CABINET MEMBER FOR ENVIRONMENT – 7 SEPTEMBER 2017 PROPOSED EXTENSION OF 20MPH SPEED LIMIT B4495 WINDMILL ROAD OXFORD

Report by Director for Infrastructure Delivery

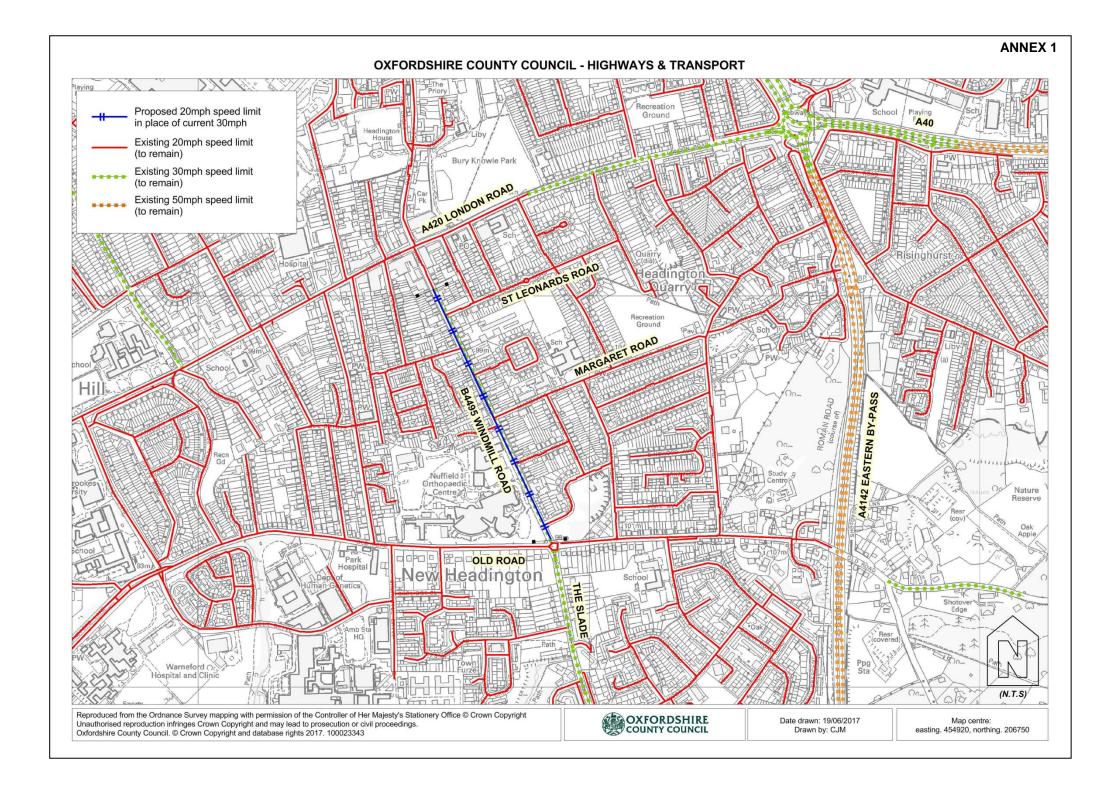
- 6. Thames Valley Police's objection was on the grounds that while average speeds were within the threshold of 24mph as recommended in the Department of Transport guidance on 20mph speed limits without supporting traffic calming measures, the speed surveys also showed that a significant

number of vehicles were travelling appreciably faster than this, and consequently it was unrealistic to expect good levels of compliance with the proposed 20mph limit. This could not only potentially lead to a more general disrespect of speed limits but also result in demands for police enforcement which cannot be accommodated within present resources.

- 7. Objections from members of the public were on the grounds that the proposal was unnecessary and could lead to driver frustration and increased delays, with one respondent suggesting that a shorter extension of the 20mph speed limit to its junction with Margaret Road, south of which the road widens, might be more acceptable.
- 8. Expressions of support primarily cited improved safety for all road users and in particular children, pedestrians and cyclists. However, several of these responses also stated the importance of enforcement of the lower speed limit should it be approved and that without this its benefits would be much reduced.

- 9. The concerns of Thames Valley Police on the likely high levels of abuse of the speed limit are noted and it is accepted that police resources for speed enforcement including by the use of speed cameras are already under severe pressure and that it would, therefore, be unrealistic to expect significant enforcement of the proposed 20mph speed limit.

- 10. The objections from the members of the public on the grounds of need are similarly noted. However, the accident record of the part of the road where the reduced limit is being proposed (one serious and seven slight accidents have been reported in the latest 5-year period available, to 31 July 2017) does point to there being valid safety concerns, even when allowing for the fact that the circumstances of some of these incidents were low speed collisions.

- 11. The significant number of responses in support of the proposal notwithstanding that some of these were qualified by concerns over its benefits in in the likely absence of any appreciable enforcement activity given the severe pressures on police resources is noted and it would, therefore, appear that the proposal has significant local support, together with that of Cyclox, representing wider cyclist interests in the city.

14. The Cabinet Member for Environment is RECOMMENDED to approve the proposals as advertised
